Memorandum

4 November 2019

To	Douglas Shire Council and Department of State Development, Manufacturing, Infrastructure and Planning		
From	Sarah Wilson - GHD	Tel	+61 7 5413 8133
Subject	Response to information request from Douglas Shire Council (DSC) and Department of State Development, Manufacturing, Infrastructure and Planning (DSDMIP) Wangetti Trail SP1 - Combined Development Application Response to request for information 1909-13127 SRA	Job no.	4132458

G:\4132458\GIS\Maps\MXD\4132458_035_WT_SP1_OW_MarinePlantDisturbance_MultiPg_Rev2.mxd
Print date: 31 Oct 2019 - 12:17

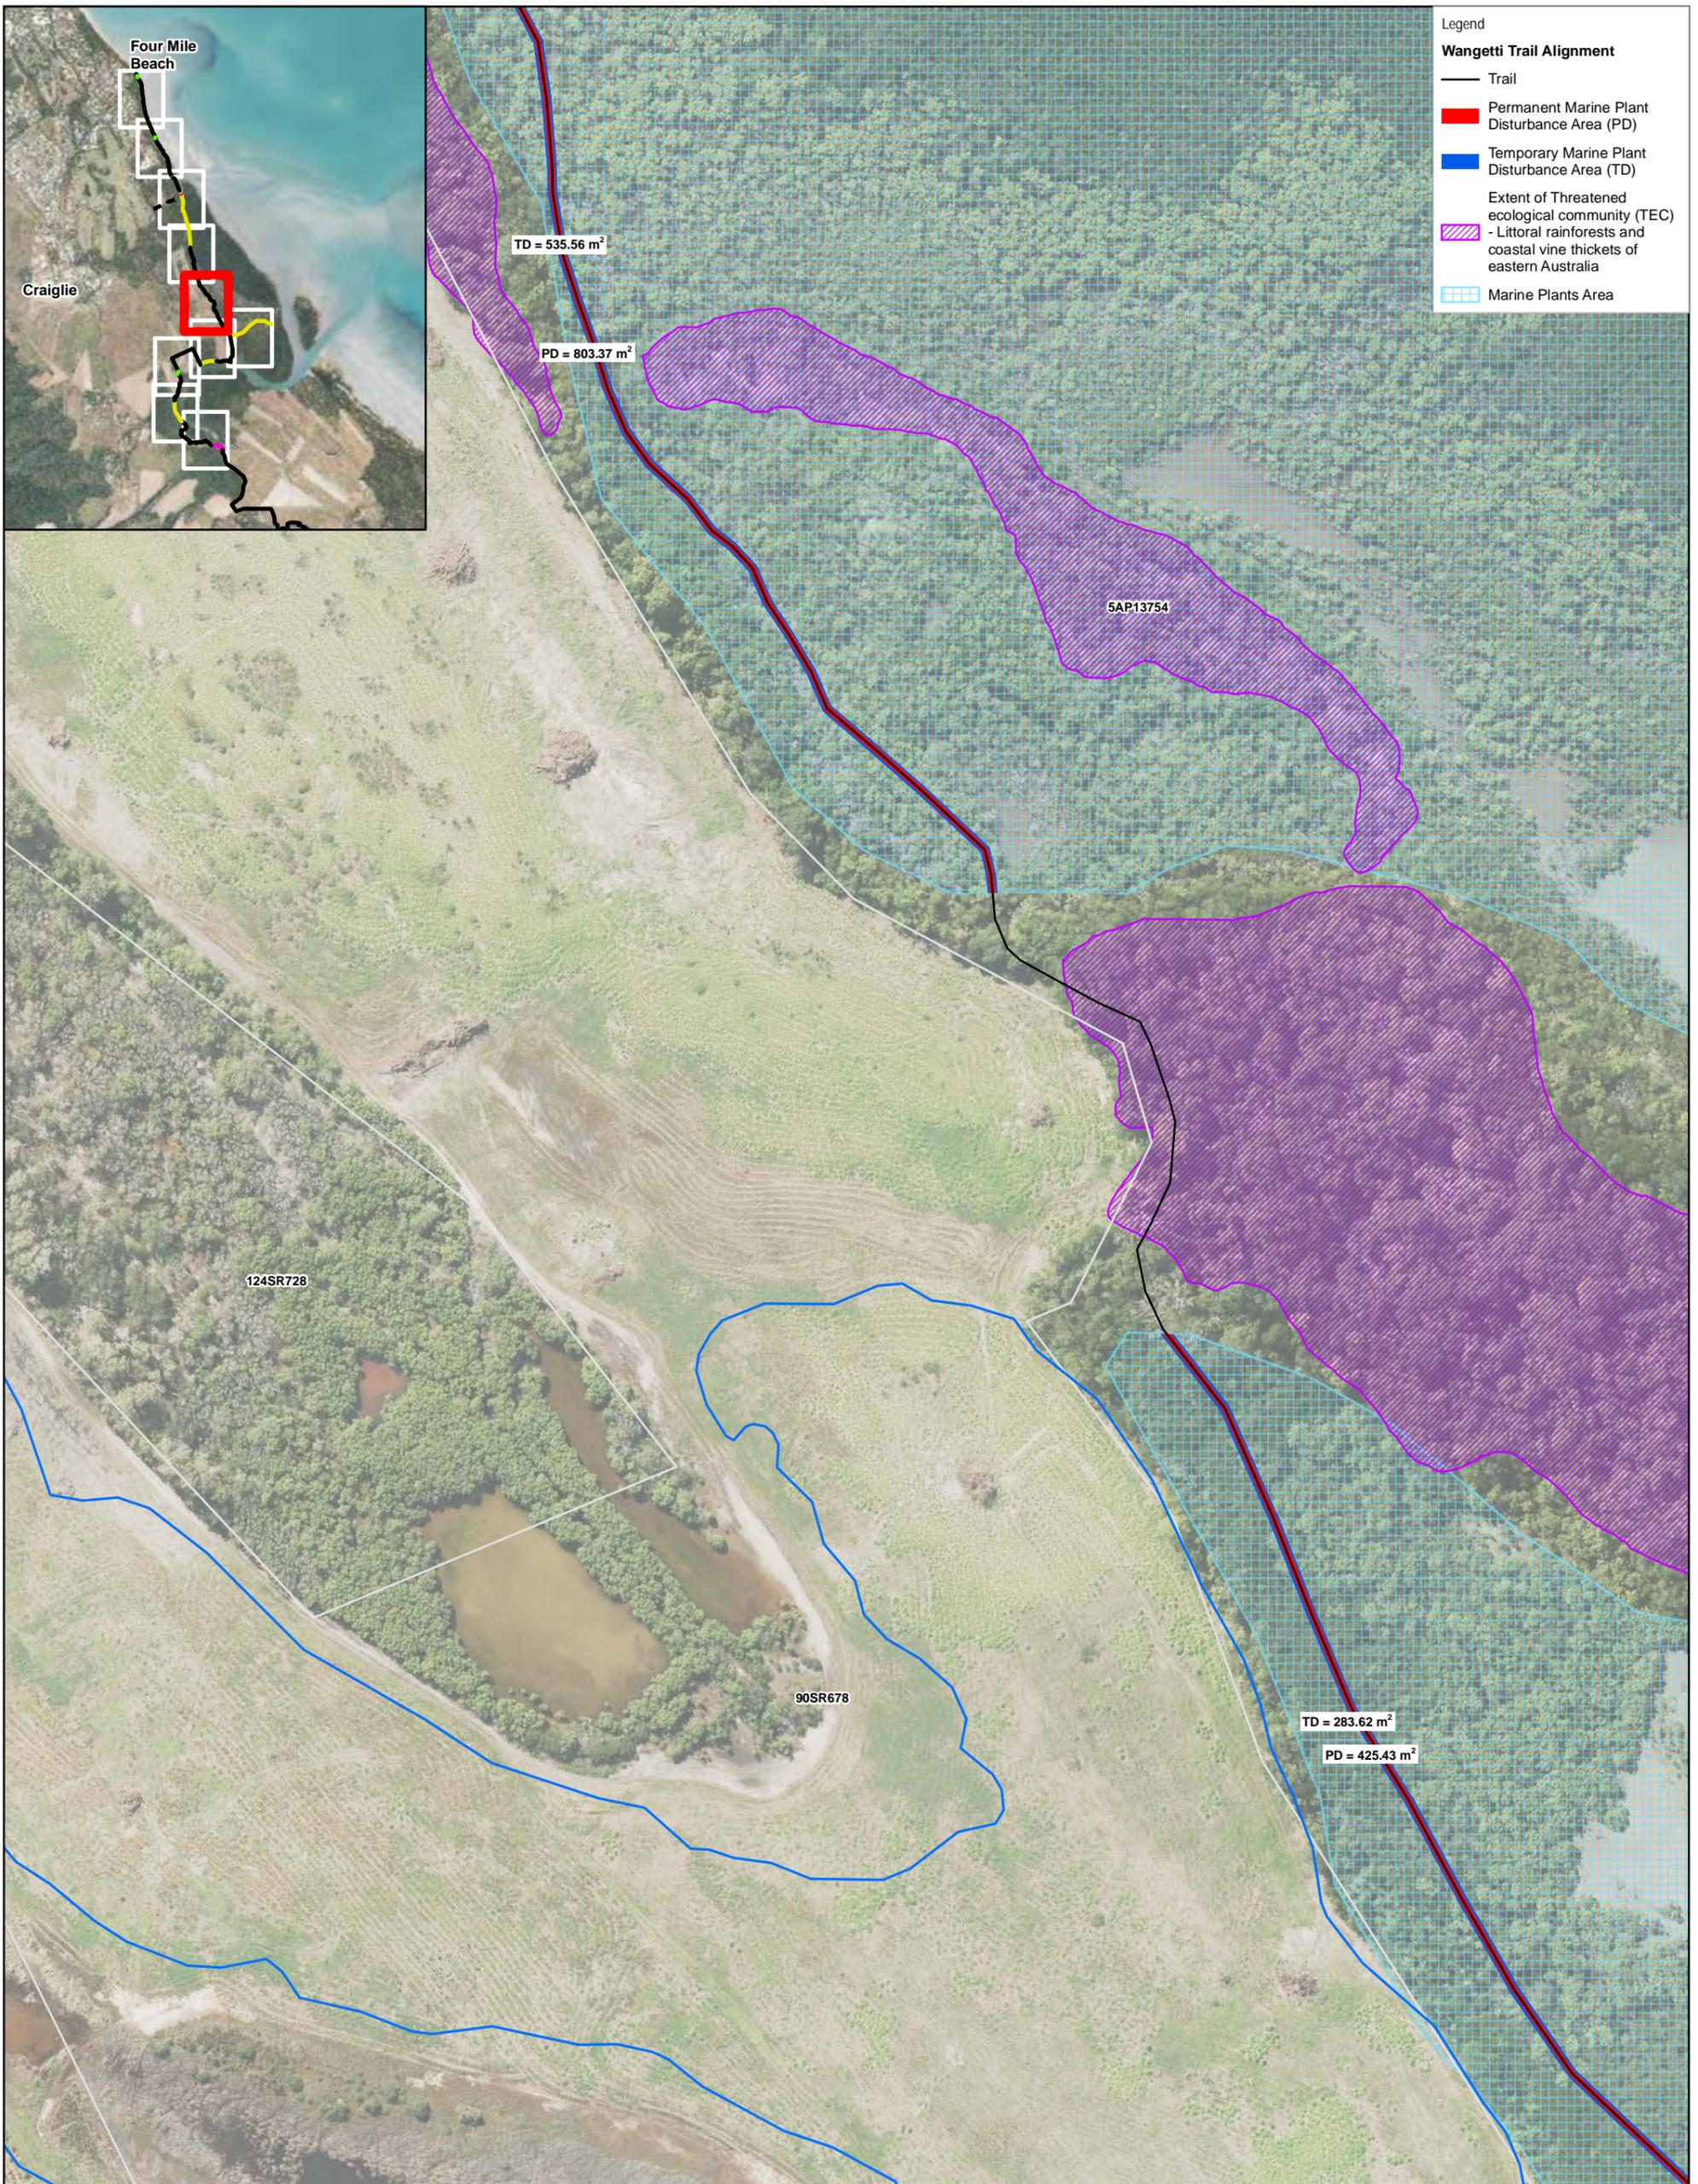
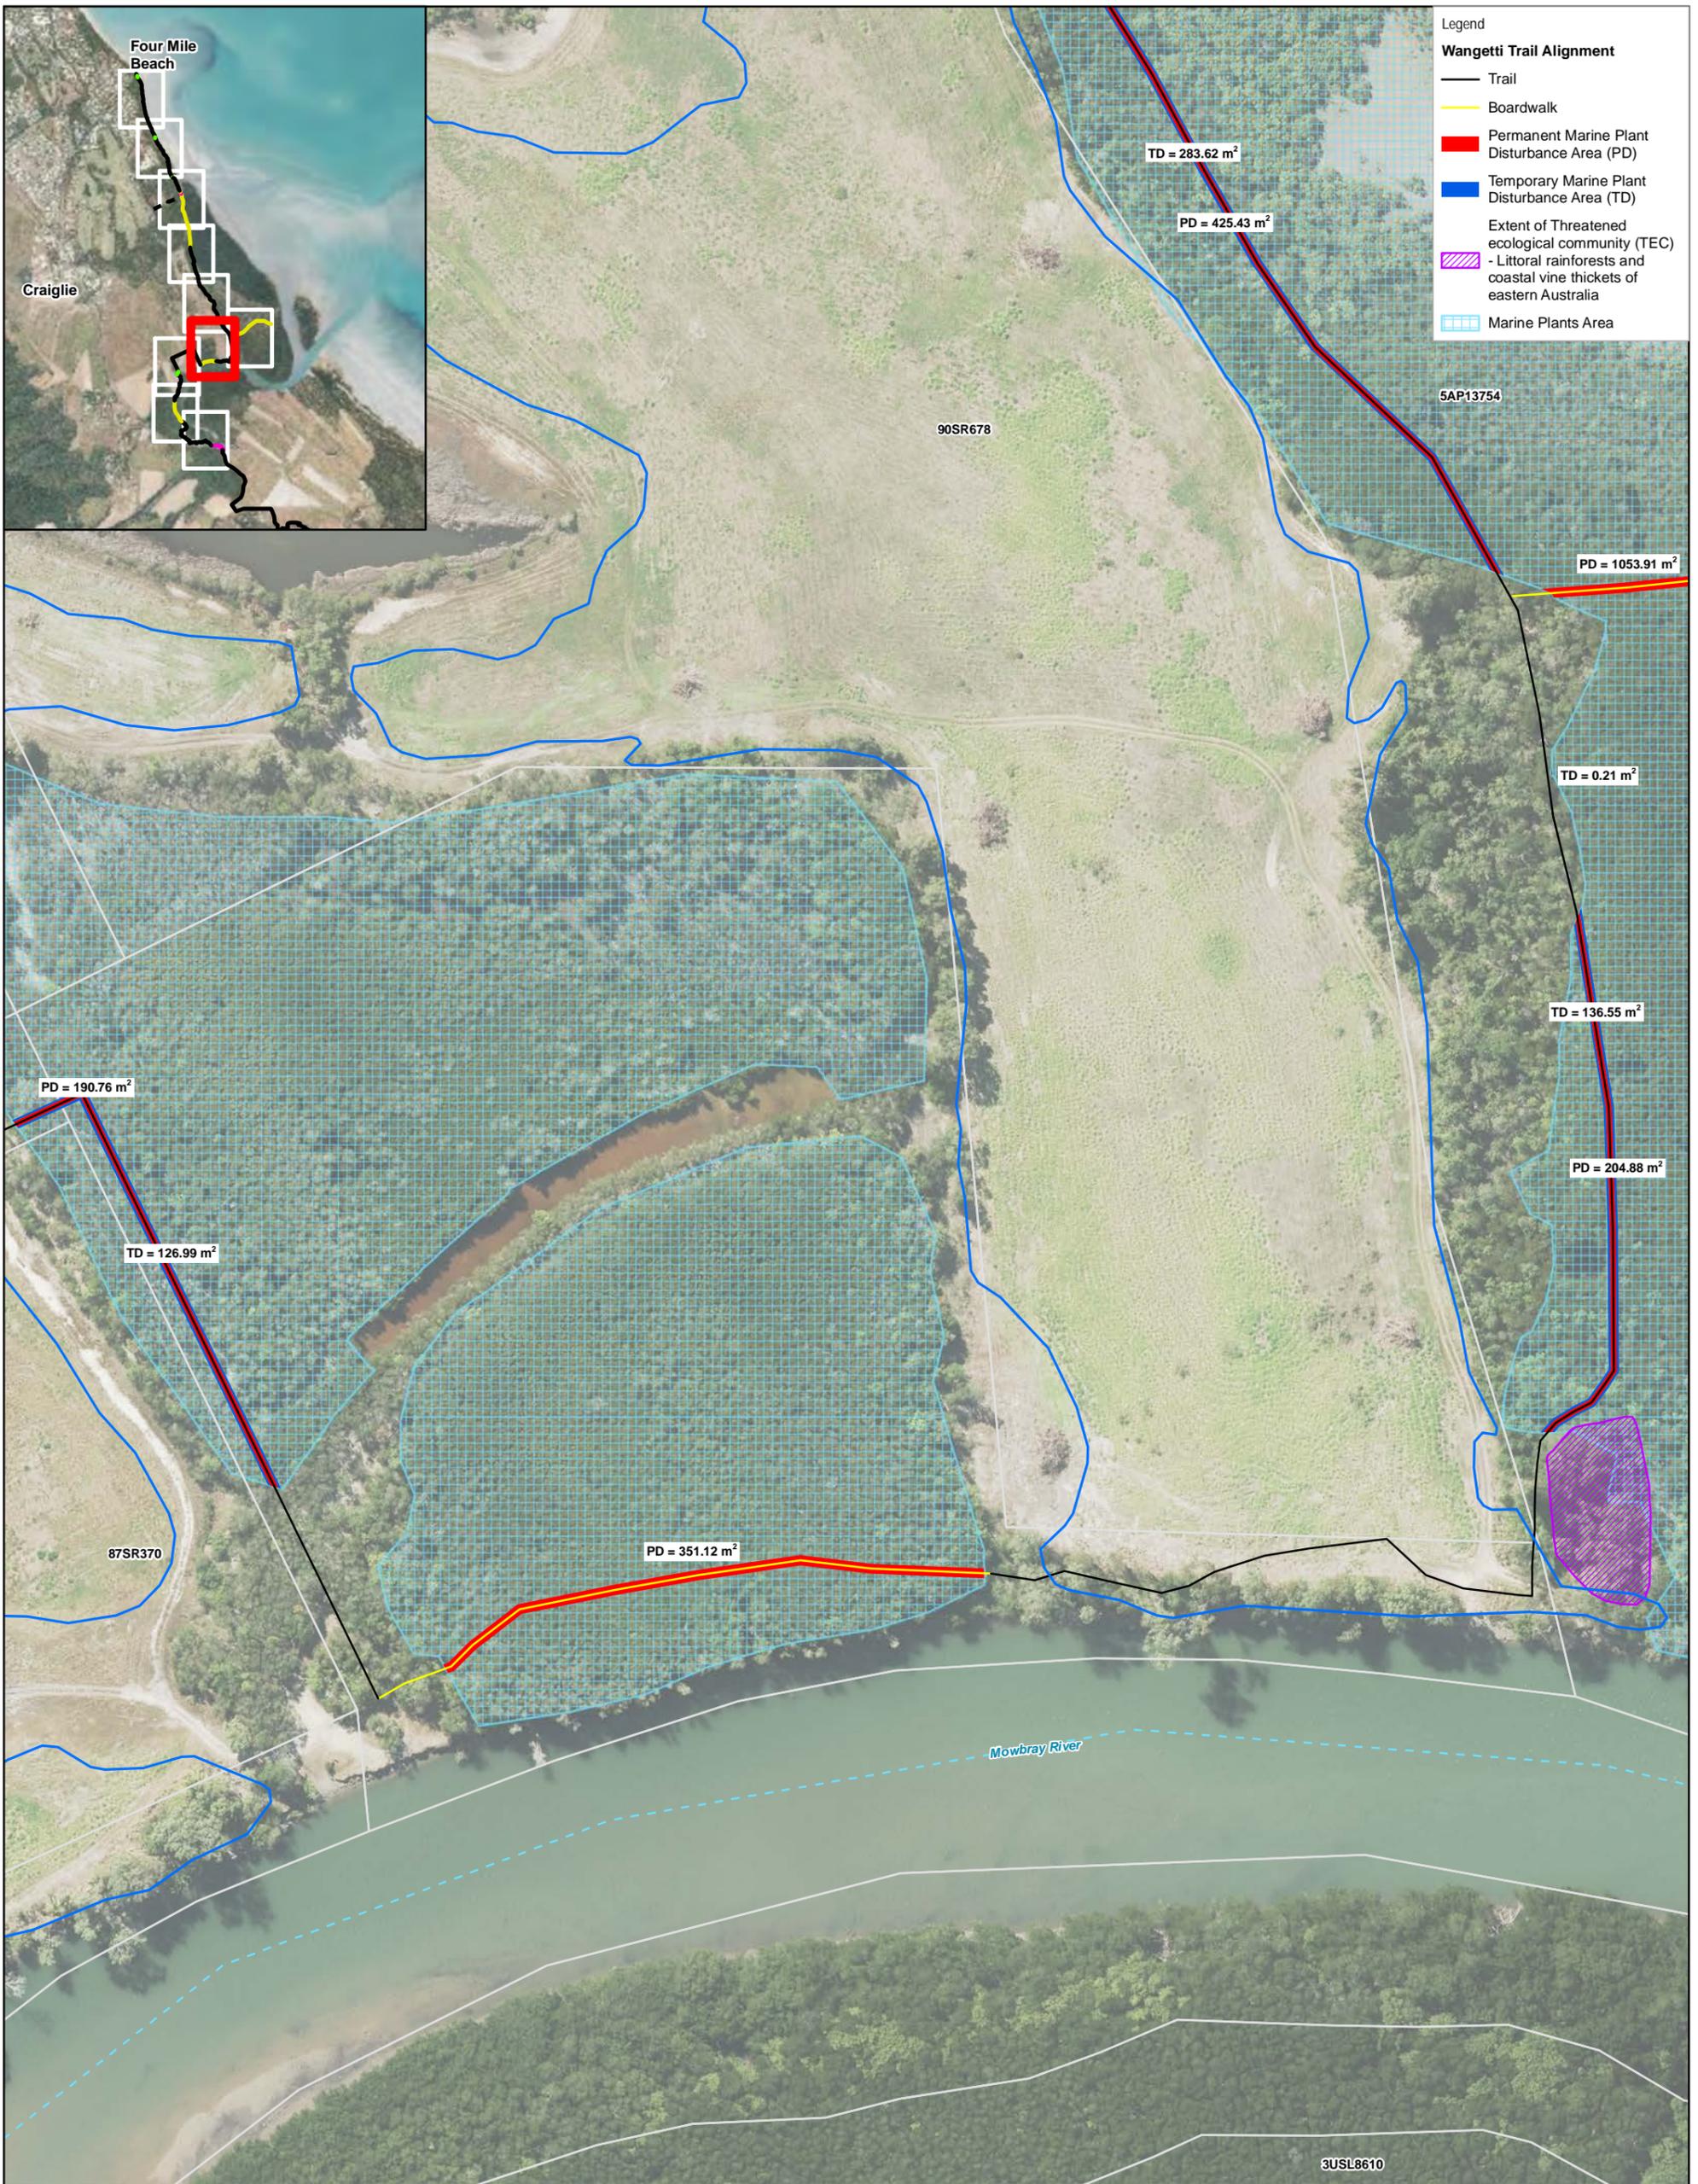
- a) Provide construction plans detailing the location and elevation of the mangrove experience board walk and observation deck.*
- b) Submit scaled drawings of the permanent and temporary disturbance areas for all ancillary infrastructure proposed at Mowbray River location.*
- c) Provide the individual marine plant disturbance area in meters squared (m²) for each works component.*
- d) Provide updated marine plant disturbance areas accounting for high fisheries significant plants.*

Item 3 (c) Provide the individual marine plant disturbance area in meters squared (m²) for each works component.

Figure 2 shows the location of the proposed trail and boardwalk and the location of threatened ecological community (TEC) - Littoral rainforests and coastal vine thickets of eastern Australia. The SP1 alignment has been designed to predominantly avoid areas of TEC, however the trail intersects with a small area of TEC, located approximately 600 m north of the Mowbray River. The TEC was not previously mapped in government databases and was recorded during the site investigation of the area. Based on the composition of the vegetation within the TEC area, it was determined not to contain high fisheries significant plants.

A breakdown of the marine plant disturbance including temporary and permanent disturbance has been provided in Table 3-2 of the Environment Assessment Stage 2 Wangetti Trail Planning Report for Operational Work - SP1 Marine Plant Disturbance Report and is outlined in Table 5 below and shown in Figure 2.
